EEVC-WG12 Update on EUROSID-2 Dummy Activities

Dr. Michiel van Ratingen
Chairman of EEVC WG12

Variation of Performance Criteria

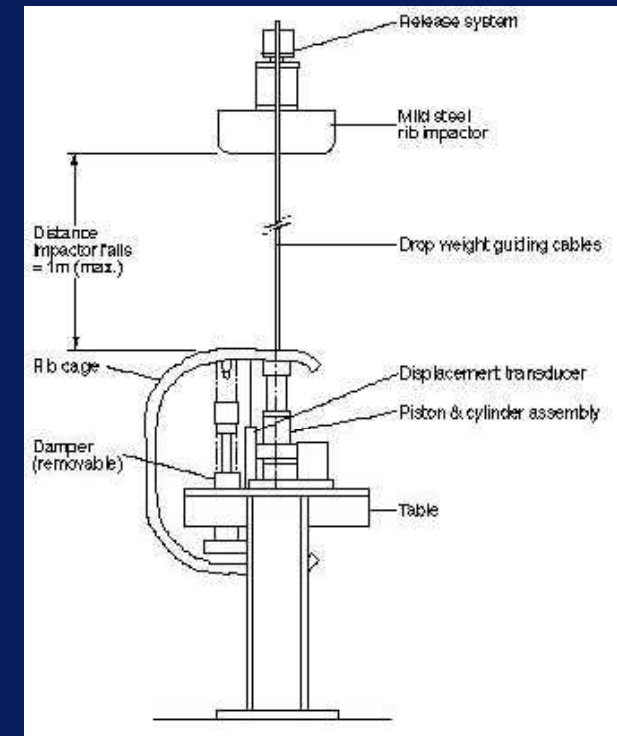
- **EEVC report explains that ES-2 has lower criteria than EUROSID-1 in biofidelity tests**
- **This depends on test conditions**
- **Too much data are missing to make complete analysis**
 - no maximum rib deflections in sled tests are given
 - test results at lower velocity (e.g. 8.9 m/s in ISO condition) may give more insight

- Goal of ES-2 development has been to keep same level of biofidelity to EUROSID-1 w.r.t. accepted EEVC requirements
- WG12 has checked ES-2 performance in thorax and full body (thorax/pelvis) response
- Responses of PMHS rib deflection and V^*C are not available and therefore not included in the assessment

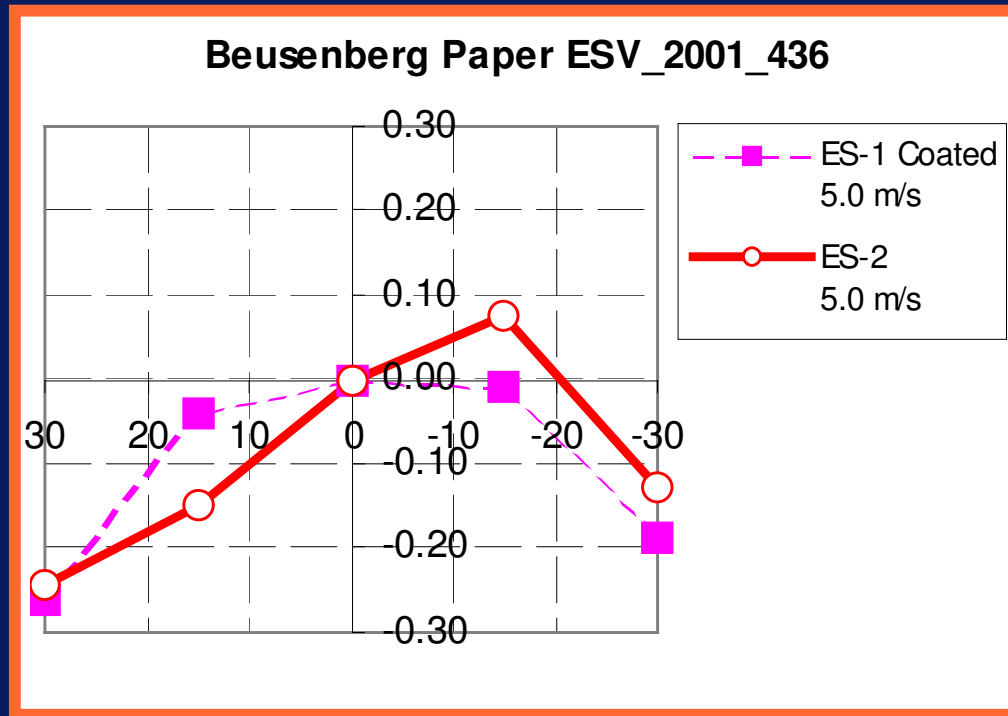
- Surprisingly higher rib deflections are observed at rearward angle impacts for ES-2
- Data to compare with production EUROSID-1 are missing in the EEVC report
- Change in position of rib displacement can have a negative effect on the measured values of the displacement when oblique loading is present

- **Conclusion in EEVC report based on impactor data**
- **Additional directional impact data available on EUROSID-1 and ES-2 include:**
 - Biokinetics study, 23.4 pendulum impact tests on EUROSID-1 (coated piston) and ES-2 @ +30, +15, 0, -15 and -30 deg
 - NHTSA study, 907 bumper pendulum impact tests on EUROSID-1 (coated piston) and ES-2
 - TNO biofidelity tests 23.4 kg pendulum tests on EUROSID-1 EUROSID-1 (coated piston) and ES-2 @ +30 and 0 deg
 - TNO rib only drop tests (+20, +10, 0, -10, -20 deg)

Inter Rib Homogeneity

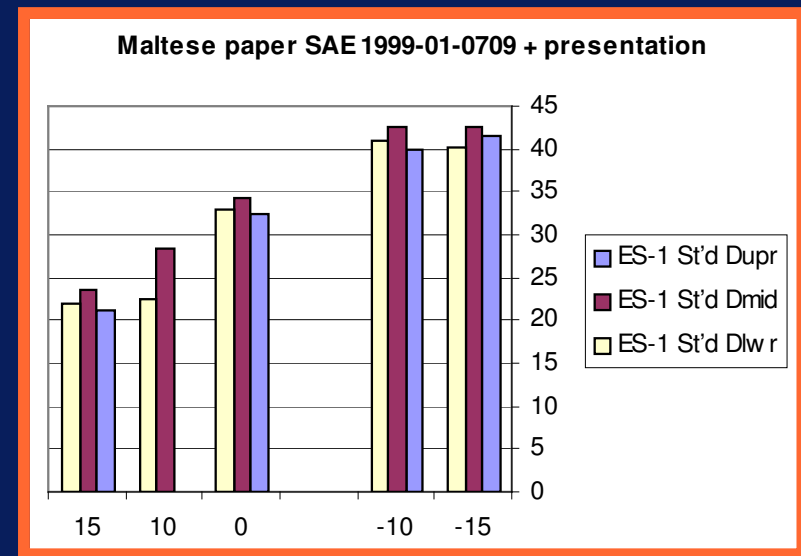
- **Evolution of rib responses between EUROSID-1 and ES-2 is not continuous**
 - Reference is made to EUROSID-1 prototype data by Friedel et al.
- **Effect on maximum deflection and/or V*C may be greater for the individual ribs than indicated by the average given in the EEVC report**

- Friedel et al. data shows evidence of flat-tops at angled impacts, suggesting rib binding for EUROSID-1
 - The European side impact dummy EUROSID, Proceedings of the seminar held in Brussels, December 1996, Fig 6, page 96
- NHTSA bumper pendulum data on EUROSID-1 does not show continuous response

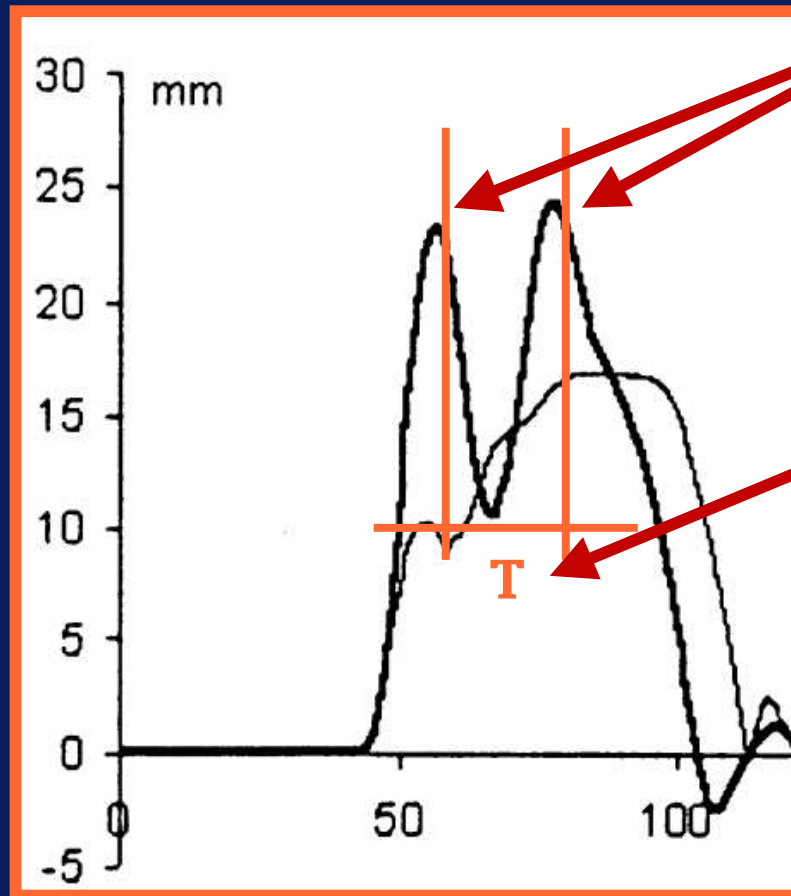
- Friction is eliminated in ES-2 and compensated by increasing tuning spring stiffness
- This leads to stiffer thorax with less overall damping which is not appropriate

Thorax Damping Characteristics

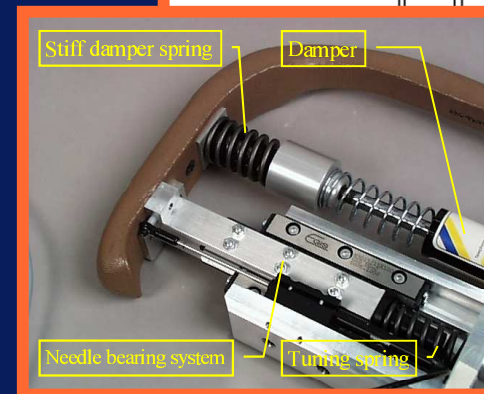
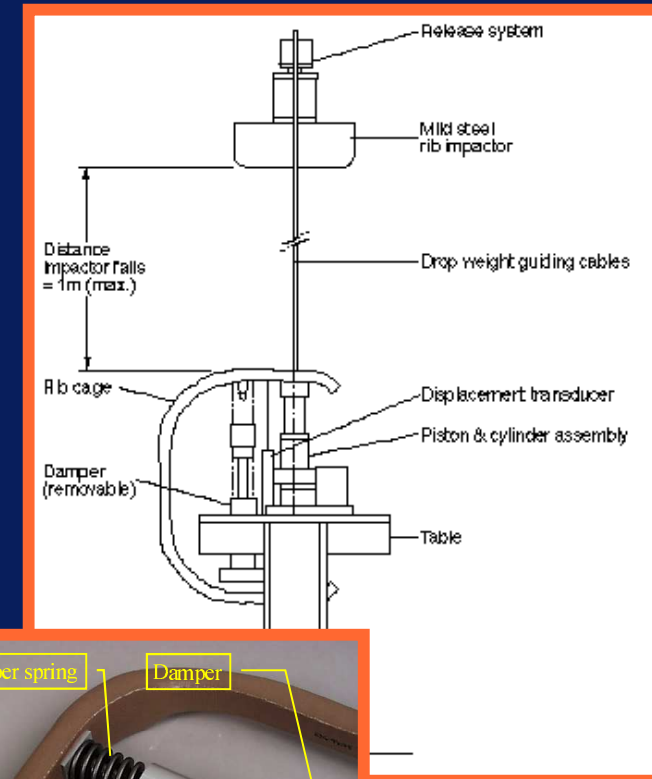
Double peak of same magnitude at small deflection

Oscillations (~50 Hz) observed on three ribs

- Theoretical calculation of eigenfrequency shows differences are small between EUROSID-1 and ES-2
- New series of rib only tests performed at TNO/FTSS to further vibration behaviour of EUROSID-1 and ES-2
